DESIGN REVIEW BOARD

March 9, 2016

DESIGN REVIEW BOARD STAFF REPORT

Design Review Number:	16-03-DRB	Meeting Date	March 9, 2016
Applicant:	David Barone		
Property Address:	1105 Second Street		
Application Date:	February 3, 2016		
Project Description:	New sign plan

SIGN #1

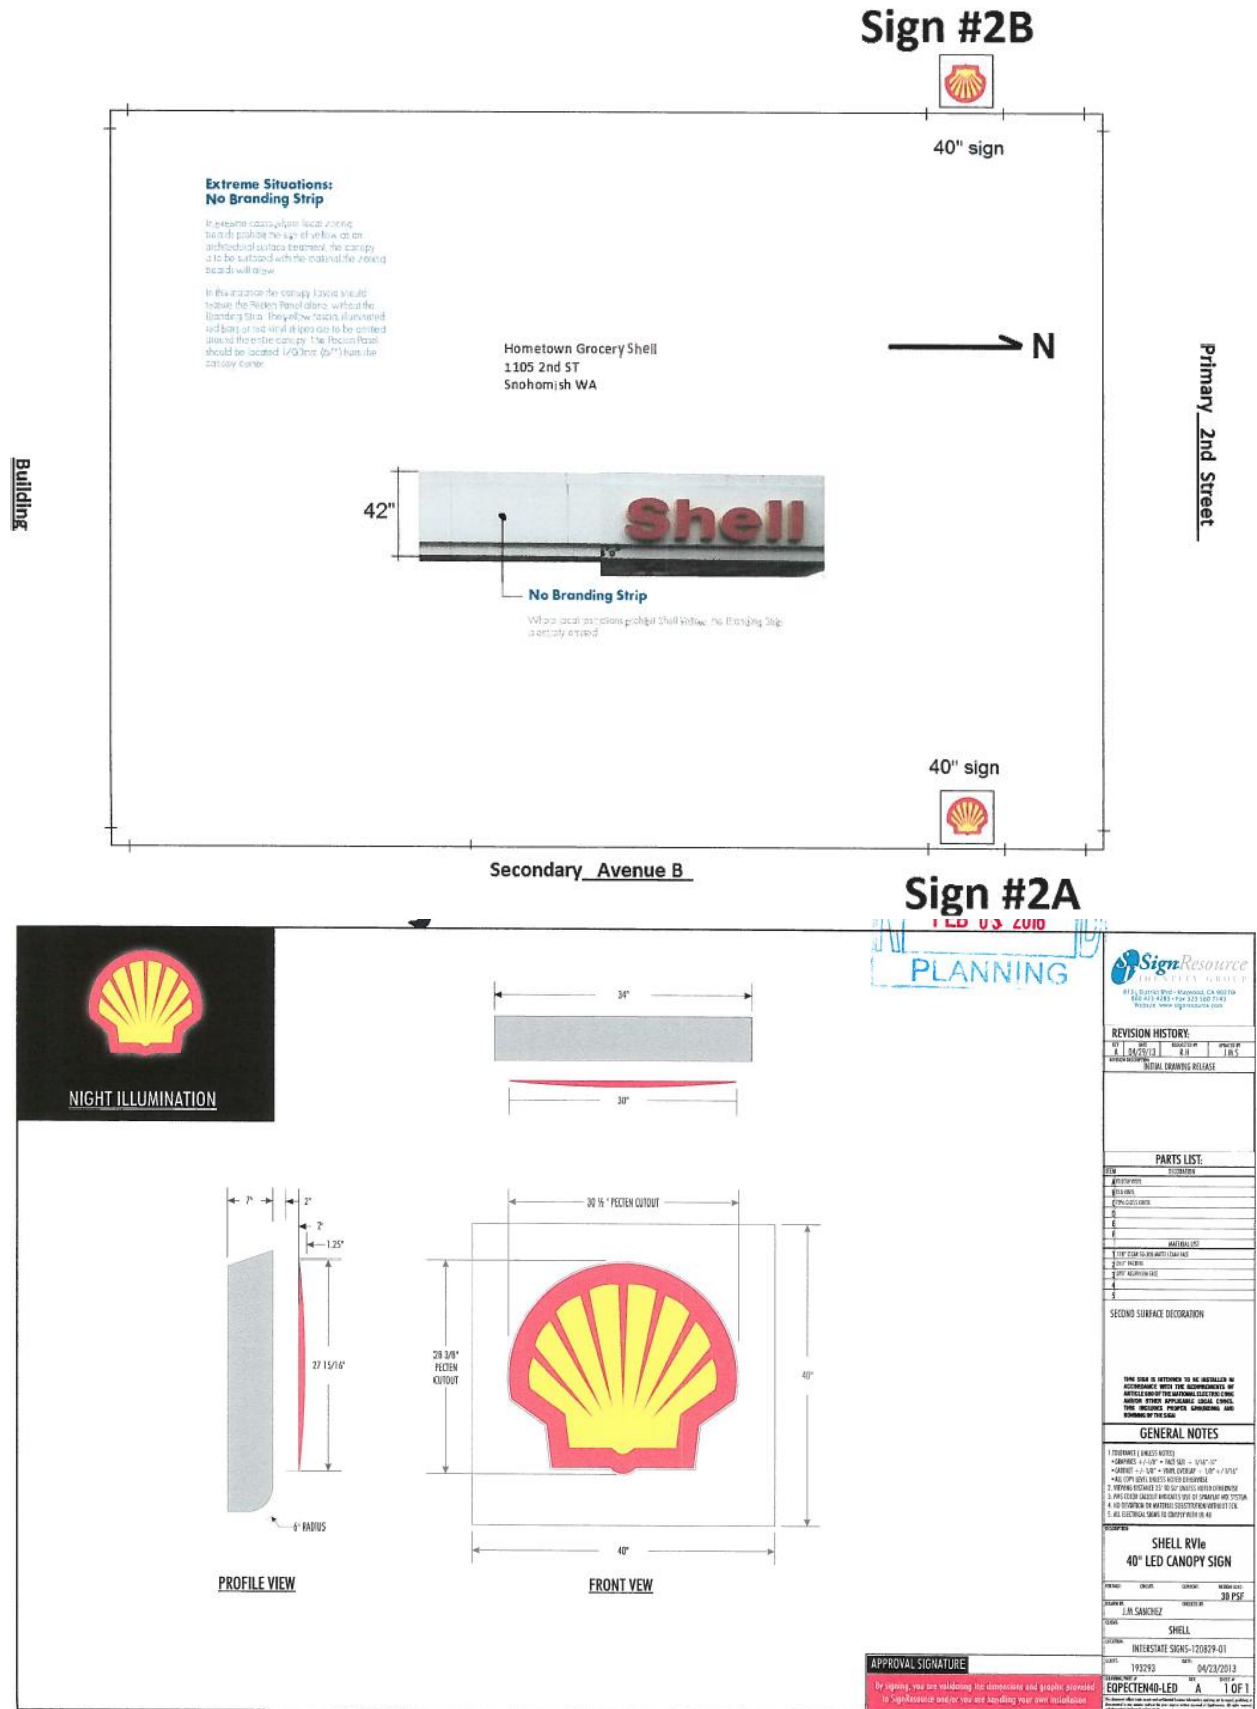
Electronic changing message signs not allowed in the Historic District per SMC 14.245.085B.

Optional Manual tile when LED is not allowed

Requires proof of rejection to use.

Approach > Canopy > Role and Design

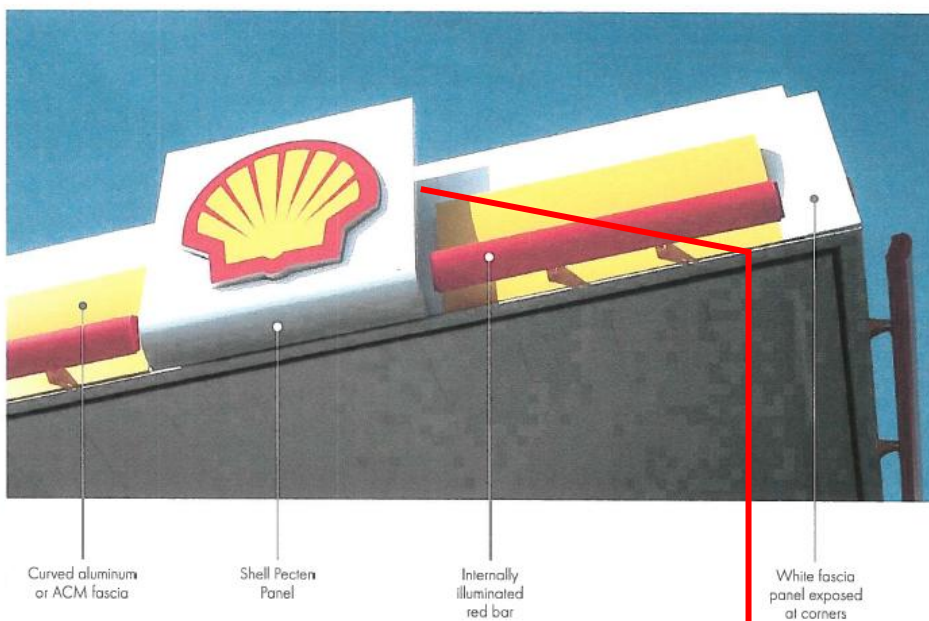
Building signs, including canopy signs, may not extend above the roof per SMC 14.245.070A.

Proposed west elevation (close-up images follow; larger versions of this image will be provided at the meeting)

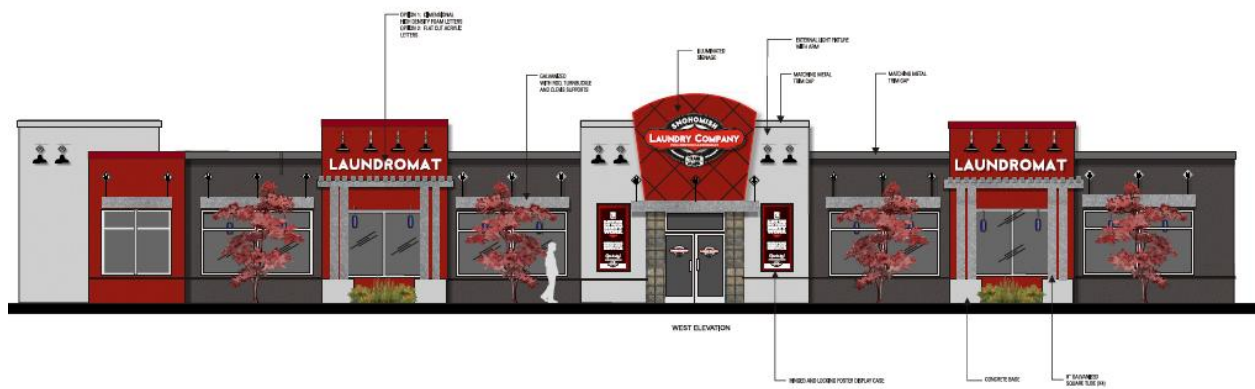
Staff comments: The standard does not appear to be met. The south façade on Pearl Street currently has two large recessed windows. As proposed the façade will be an unarticulated wall with a mandoor on the far east side and two trellis structures.

Staff comments: As proposed, the Pearl Street side of the building is a nearly 42-foot wide, undifferentiated façade. The Board may wish to recommend a condition of approval that some treatment is added to this façade.
